Skidders Adventure Playground Stage 1 Upgrade

Engagement two (concept plan) summary report – April 2023

Skidders Adventure Playground Concept Design

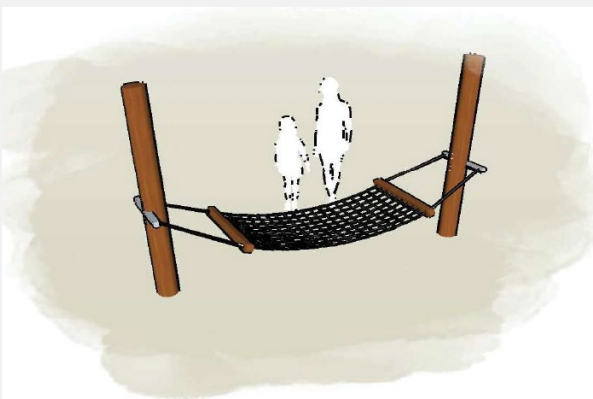
Question	Yes	No	Tell us why
Do you like where the play equipment is placed in the playground? 	8 responses	0 responses	YES - NO - OTHER <ul style="list-style-type: none"> • “Where is the rest?” • “Waterslide with motor that turns on & off with remote”

<p>Would you enjoy playing on this? Multi-play unit</p> 	14 responses	1 responses	<p>YES</p> <ul style="list-style-type: none"> • "So cute ♡" • "Favourite, so much fun" <p>NO</p> <ul style="list-style-type: none"> • "Want it higher" <p>OTHER</p> <ul style="list-style-type: none"> • "Slide colour with flames" • "Can we get 2 (slides)?"
<p>Would you enjoy playing on this? Spinning mushroom</p> 	11 responses	0 responses	<p>YES</p> <ul style="list-style-type: none"> • "Because it's fun!" • "Playing & fun" <p>NO</p> <p>-</p> <p>OTHER</p> <ul style="list-style-type: none"> • "😊"
<p>Would you enjoy playing on this? Hammock swing</p> 	11 responses	2 responses	<p>YES</p> <ul style="list-style-type: none"> • "When it's hot I can lie to dry out" • "A bit fun & scary" <p>NO</p> <ul style="list-style-type: none"> • "People will get hurt" <p>OTHER</p> <p>-</p>

Theme	Feedback
Multi-play equipment unit	<ul style="list-style-type: none"> • It doesn't look like 'Skidders'. It's too cookie-cutter/generic. Looks like equipment you would find in a regular playground, not Skidders. • It looks claustrophobic • The cubby spaces are very small. The playground used to have a lot more cubbies and hiding spaces. • It is not risky enough - all the elements are enclosed with bars and mesh (e.g., the bridge, slide). • Instead of an enclosed structure and enclosed slide, what about a an open 3m high slide with an open ladder for more risky play - A single element instead of combined structure. • The high, open swinging bridge shown in the previous round of consultation is the type of risky equipment envisioned. Can this be incorporated?

Spinning mushroom	<ul style="list-style-type: none"> Like the spinning mushroom
Hammock swing	<ul style="list-style-type: none"> Skidders used to have a hammock swing, but it was larger. This would be preferred?
Seating	<ul style="list-style-type: none"> The proposed seating is ugly and doesn't suit Skidders We don't need fixed seating – prefer moveable seating and already have enough.
Other play equipment suggestions	<ul style="list-style-type: none"> Separate cubbies spaced apart so they can be used as 'bases' for running/hiding games, and other imagination play like shops. A raised cubby on stilts Waterplay elements Soccer and football are popular there should be space for these games.
Other – General	<ul style="list-style-type: none"> The options to vote on in the previous round of consultation that informed the concept plan were not risky enough. What's the rush to get play equipment installed? Since the old equipment was removed, this area is used by kids for bike riding, ball sports, running around etc. This seems like a quick fix. If there is a Stage 2, then do a full upgrade properly instead of different stages without a full plan. The kids use all of the existing equipment in this area (tyres, monkey bars, stainless steel slide) - retain all existing play equipment in this area including the steel slide.
